Indiana State University Federal Credit Union - Addition: A20-016

September 16, 2021

Addendum #2

A1.0 Architectural Site Plan

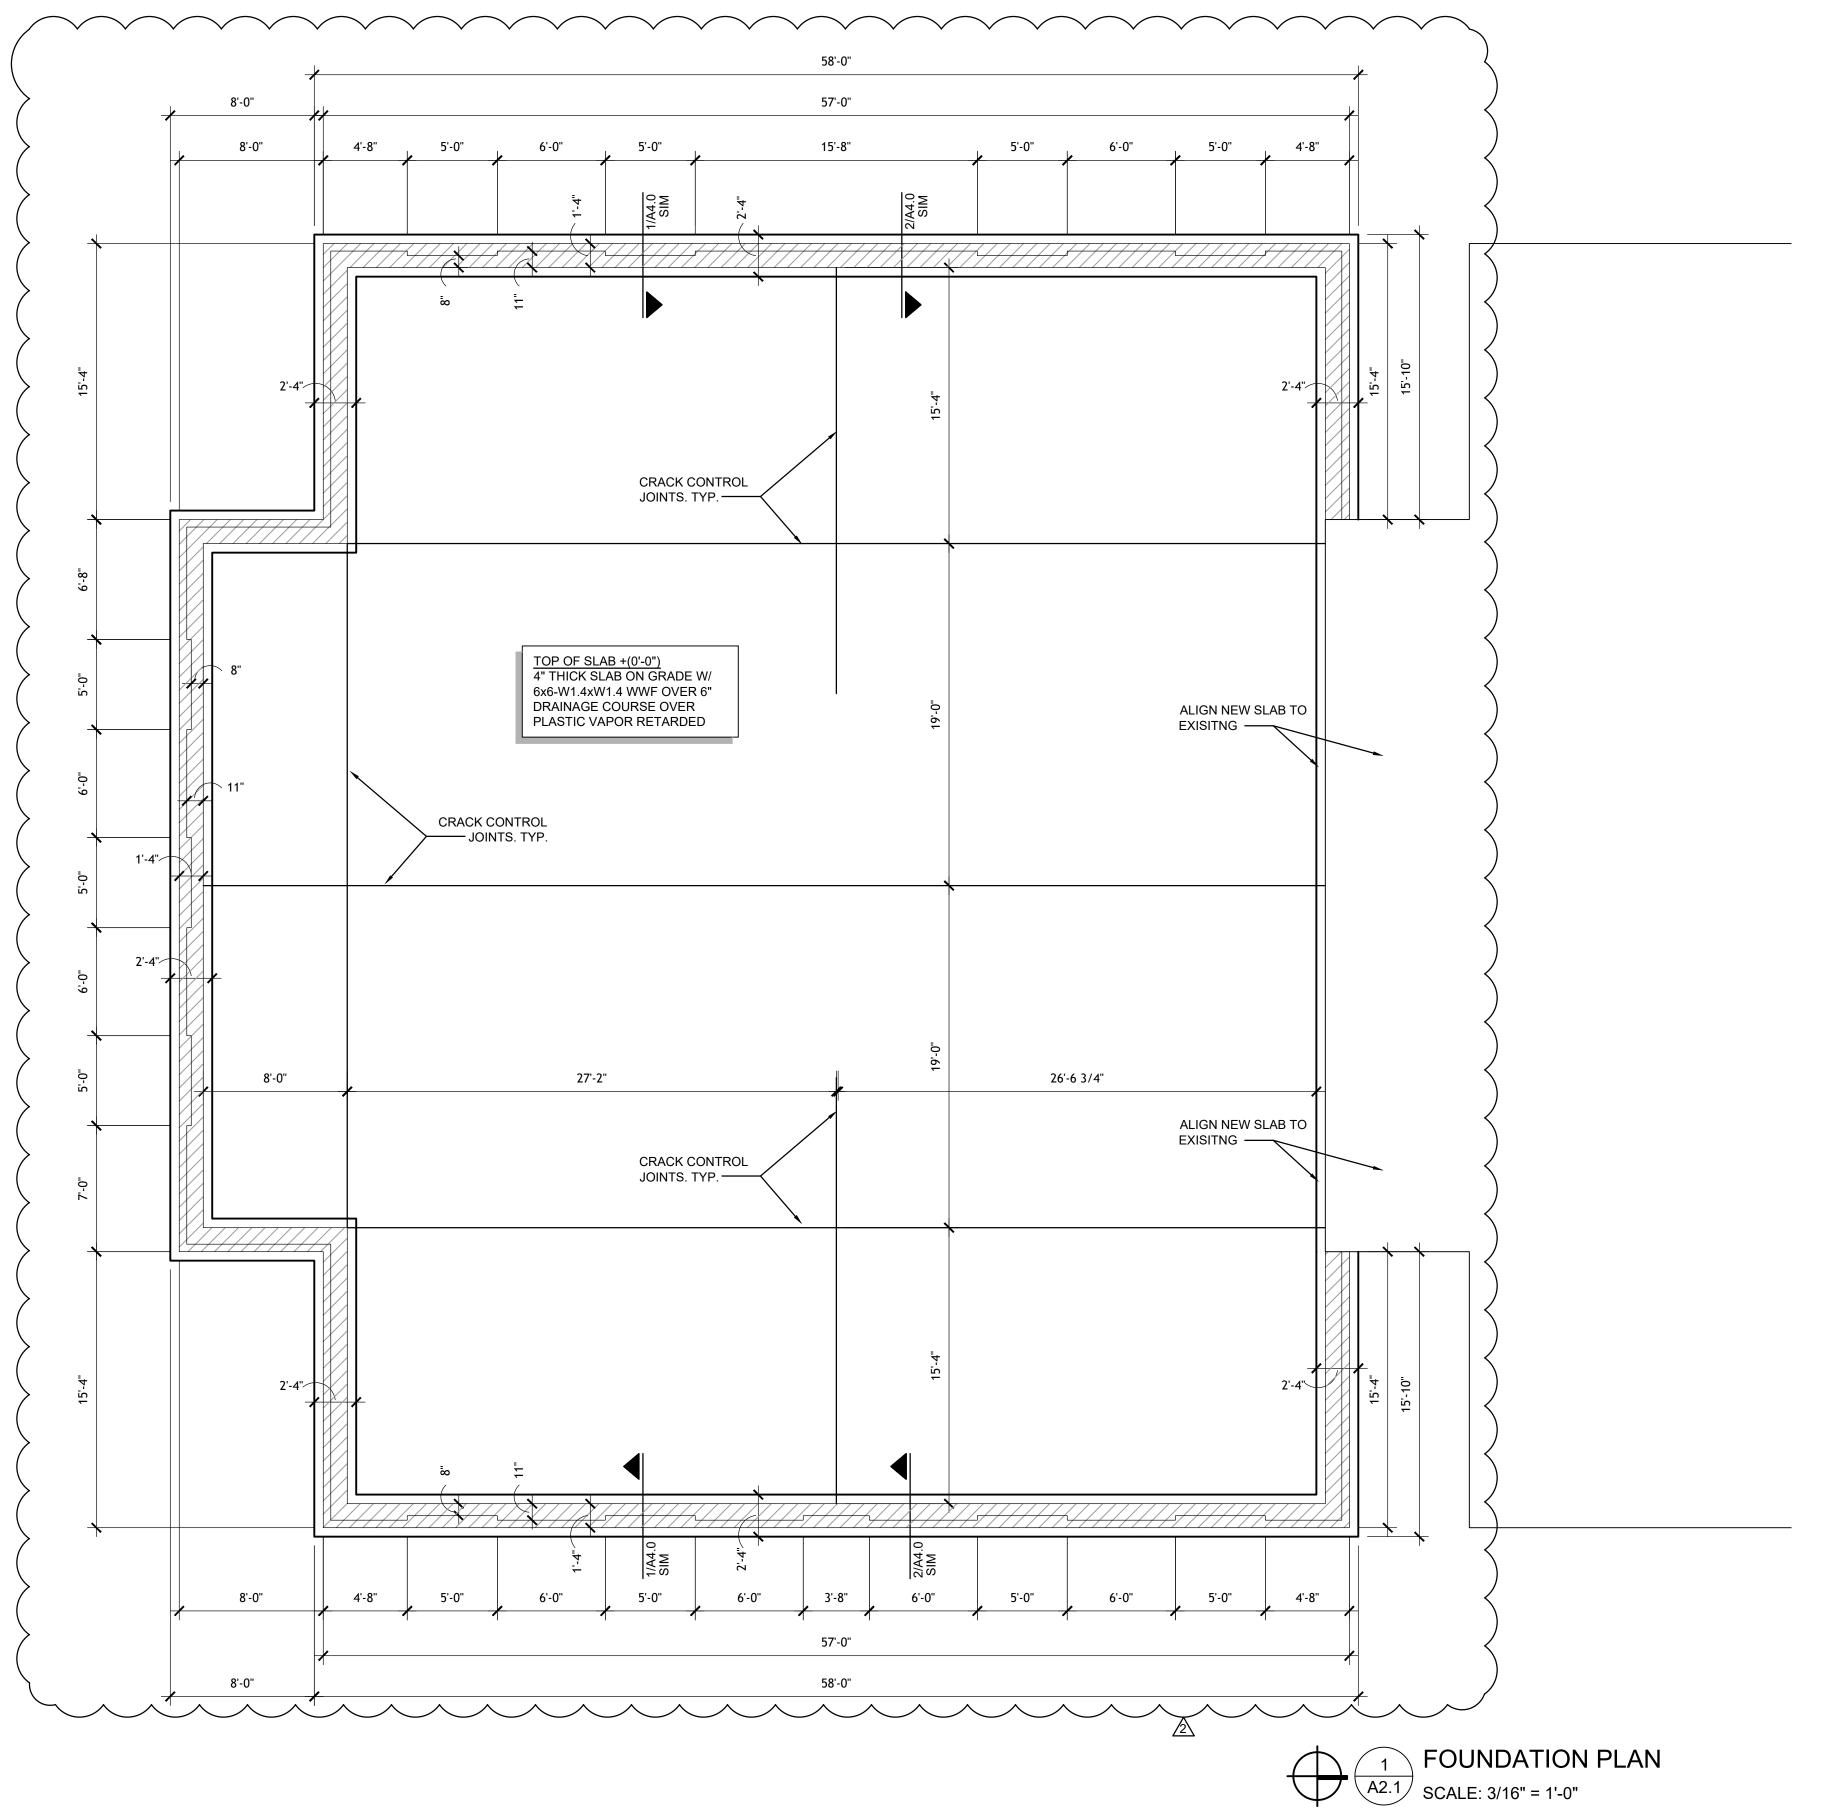
- 1. Replace sheet with attached sheet affixed with revision note '2 Addendum 2 09.16.2021'
- 2. Sidewalk note added

A2.2 Proposed Floor Plan

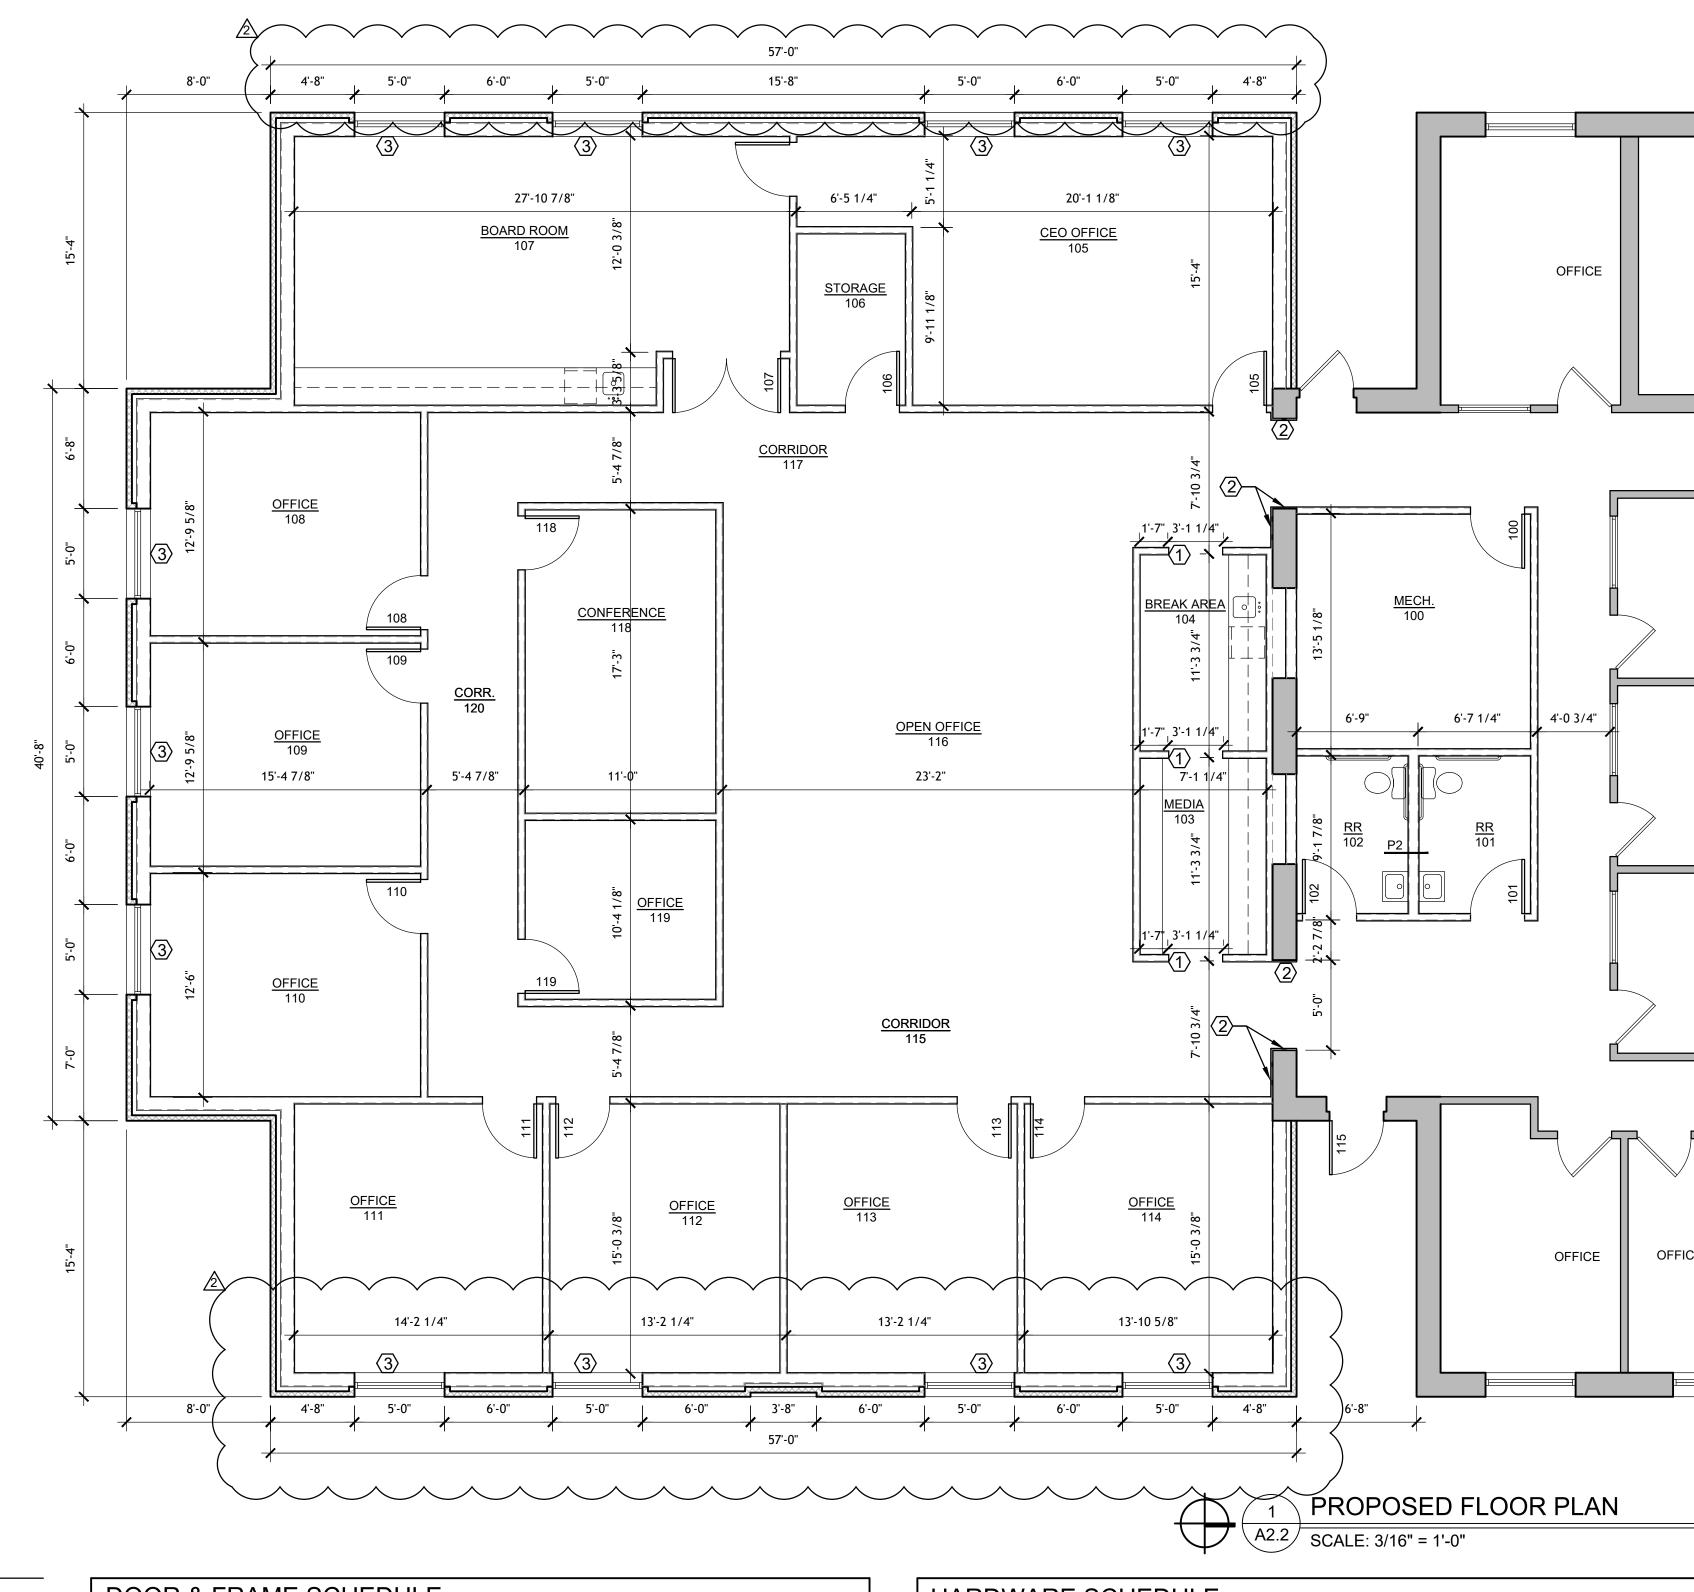
- 1. Replace sheet with attached sheet affixed with revision note '2 Addendum 2 09.16.2021'
- 2. Dimensions revised

1 FINISH PLAN
A6.0 SCALE: 1/4" = 1'-0"

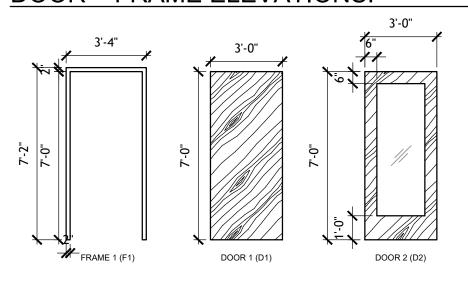
- 1. Replace sheet with attached sheet affixed with revision note '2 Addendum 2 09.16.2021'
- 2. Additional carpet locations added to scope

- 6. Install 4" vinyl wall base in Mechanical room
- Install new carpet 'C1' in existing corridors at interior renovation. Reference attached plan for extents.
